Access Compliance Report Public Rights-of-Way (Curb Ramps)

Intersection ID: 13833 Main Street: WEST BV **Cross Street: N/A** Location: NW **ADA ID: 0FE03BA97B77** Ramp Type: Combination1Diag Initial Pass/Fail: Fail **Overall Compliance: No Severity Score:** 0

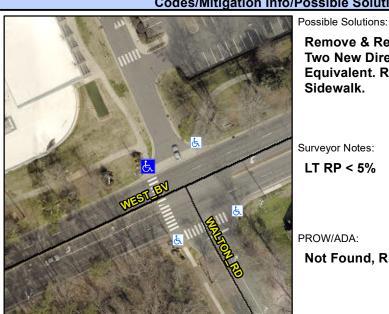
LT RP < 5%

Not Found, R304.5.3, R304.3.2

Street 1 Name None **WEST BV** Stop Condition-Street 1 Street 2 Name StopSign Stop Condition-Street 2 N/A Remove & Replace Curb Ramp With Two New Directional Ramps or Equivalent. Remove & Replace Sidewalk.
